# Droop when a Clause 104 PSE or PD PI is encompassed within the MDI

IEEE802.3dg Task Force  
19<sup>th</sup> December 2025

# Review of IEEE Draft P802.3dg / D2.2

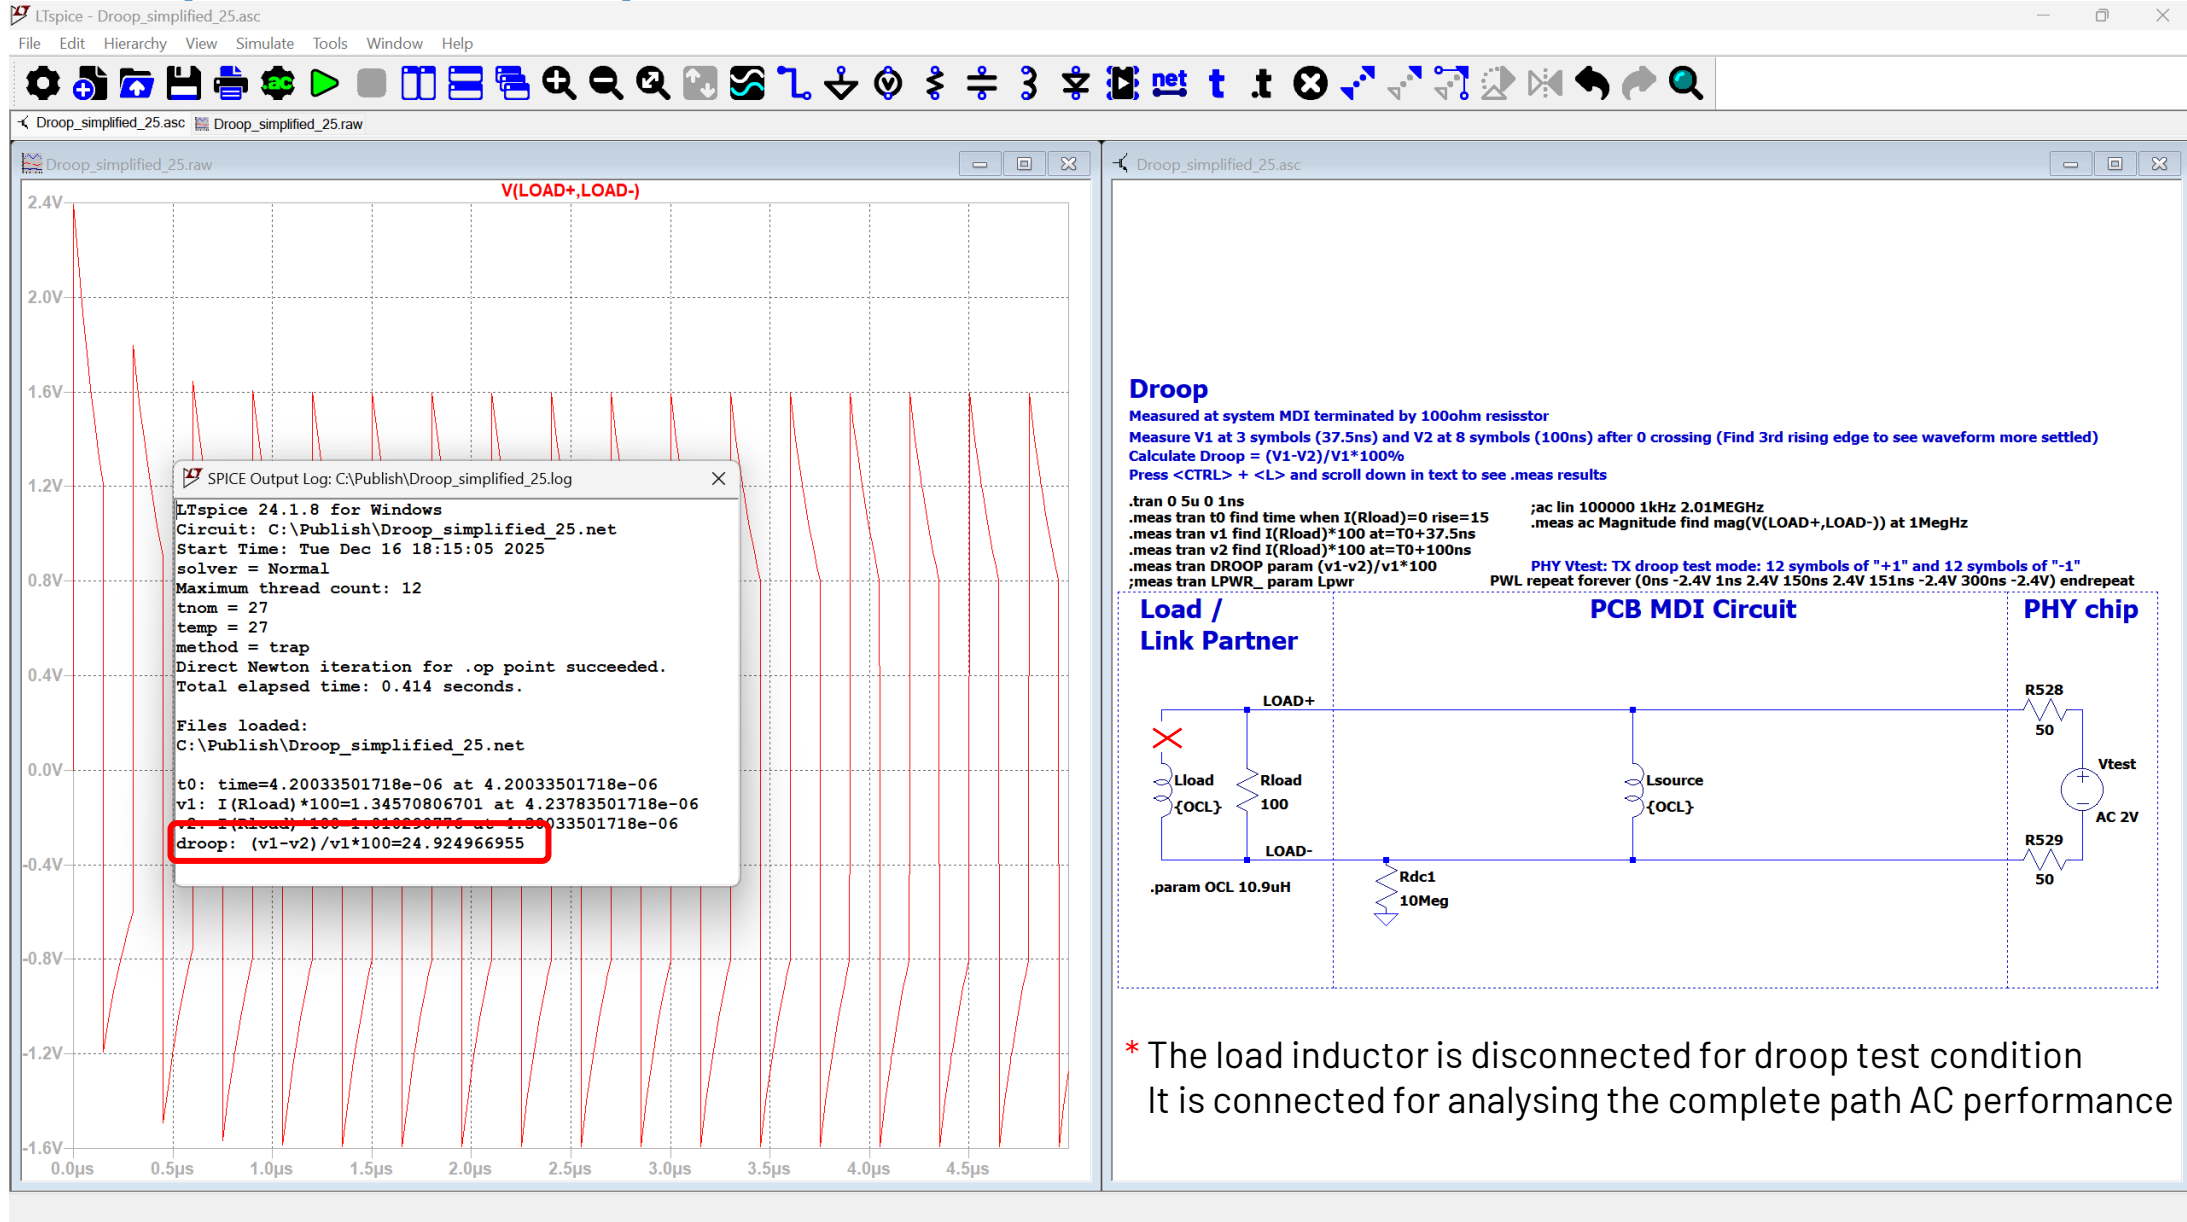
When a Clause 104 PSE or PD PI is encompassed within the MDI, the magnitude of both the positive and negative droop shall be less than 25% measured with respect to an initial value at 37.5 ns after the zero crossing and a final value at 100 ns after the zero crossing.

► The value of 25% was carried over from clause 146 without much analysis or discussion

- Since the symbol period for 100BASE-T1L is less than 10% of the symbol period for 10BASE-T1L, 25% droop is very high
- The equivalent total open-circuit inductance (OCL) to give 25% droop is about 10.9  $\mu\text{H}$
- With shunt inductances as low as this on both sides of the link there is significant in-band attenuation,  $\sim -5\text{dB}$  at 1MHz.
- This could significantly affect the link performance

# Proposal

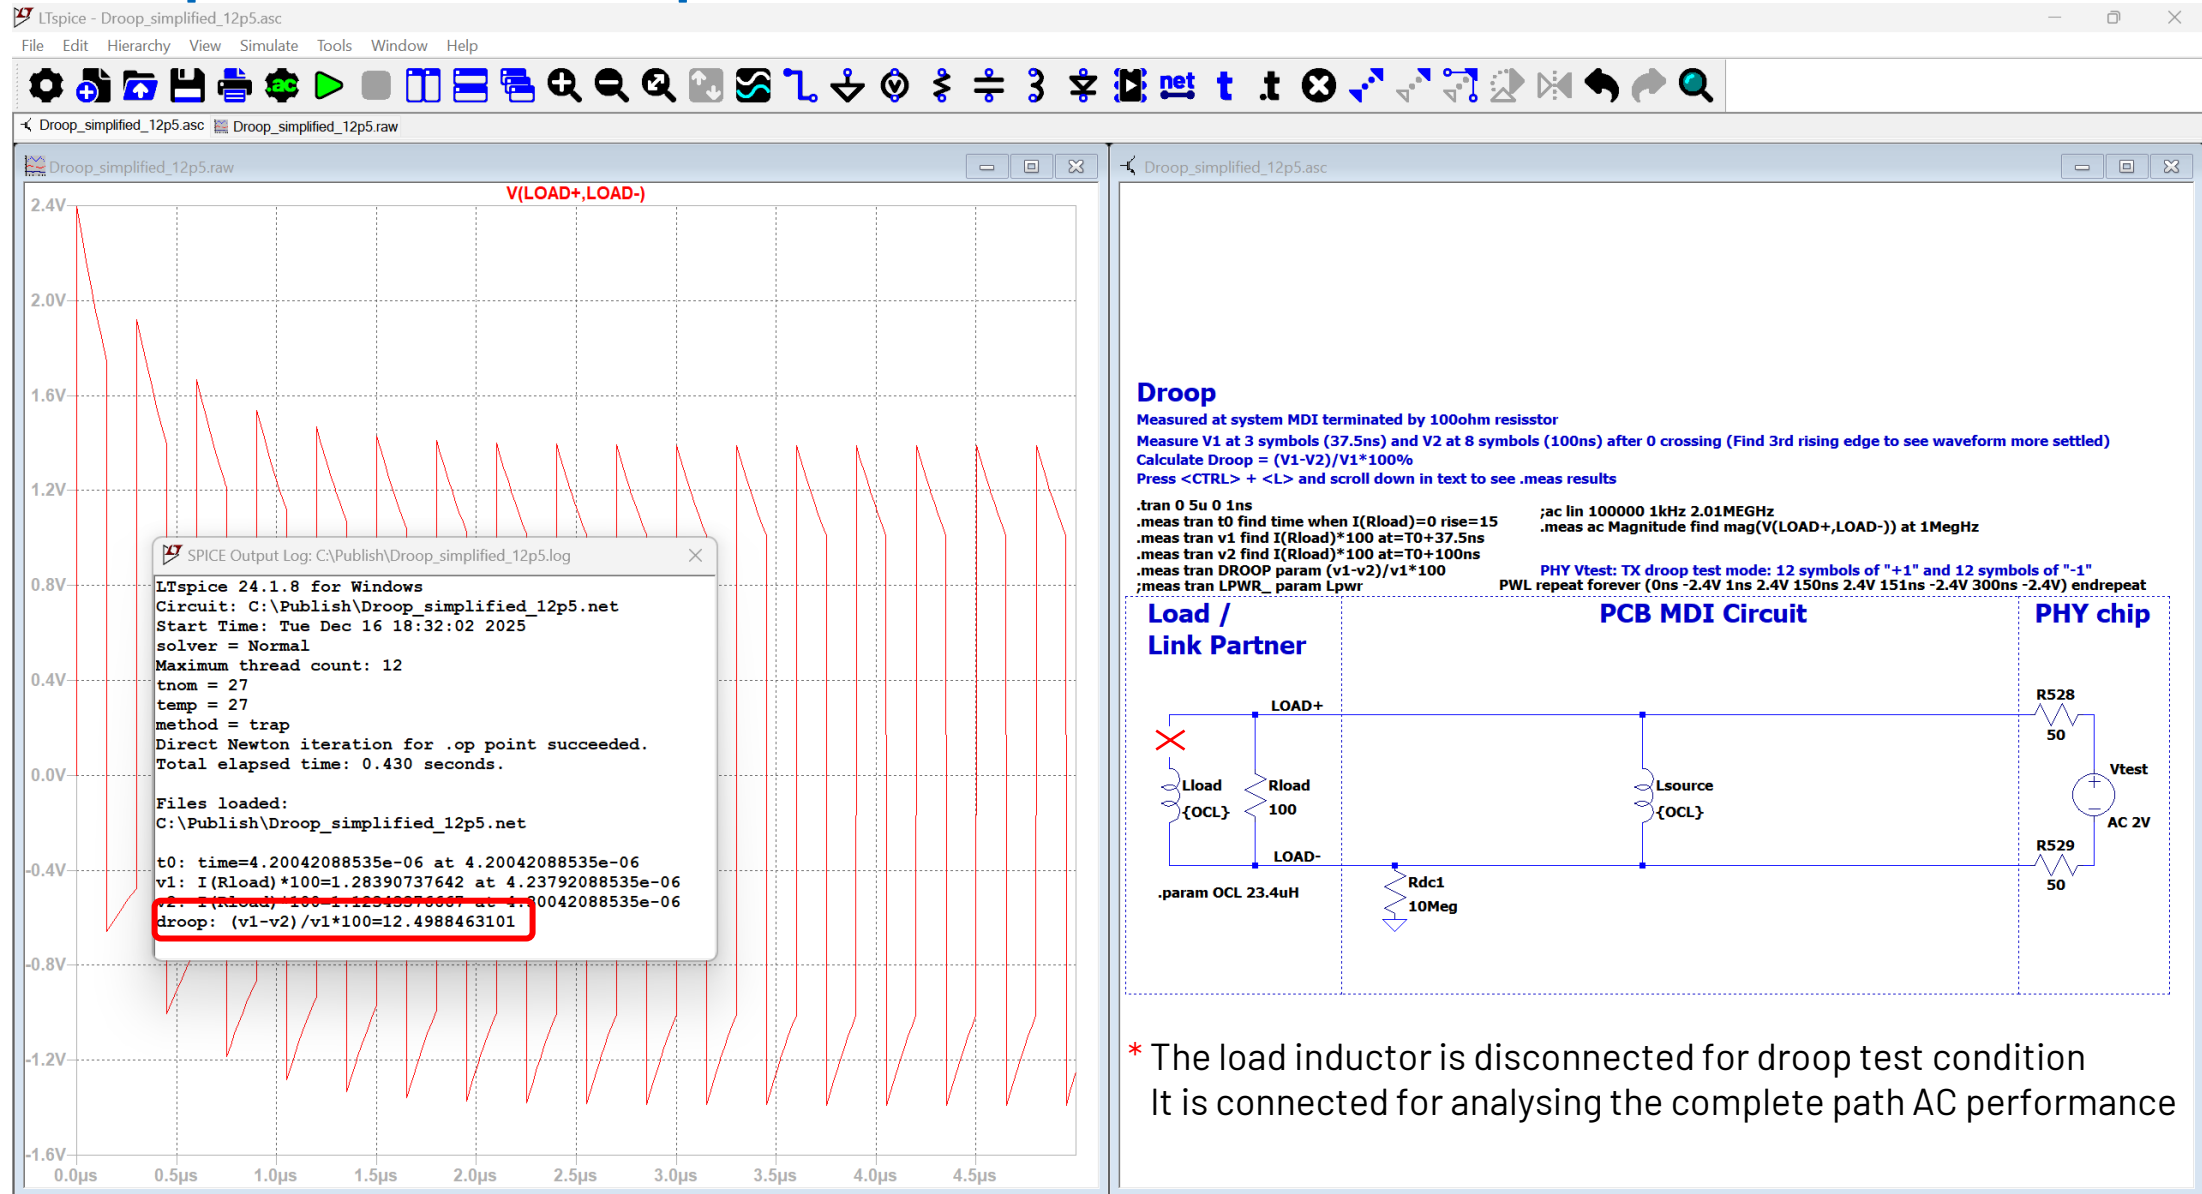
- ▶ We propose to set the limit to 12.5% measured over 62.5 ns
  - The equivalent total OCL is about 23.4  $\mu$ H
  - This would improve the in-band attenuation, to about -1.65dB at 1MHz

**When a Clause 104 PSE or PD PI is encompassed within the MDI, the magnitude of both the positive and negative droop shall be less than 12.5% measured with respect to an initial value at 37.5 ns after the zero crossing and a final value at 100 ns after the zero crossing.**
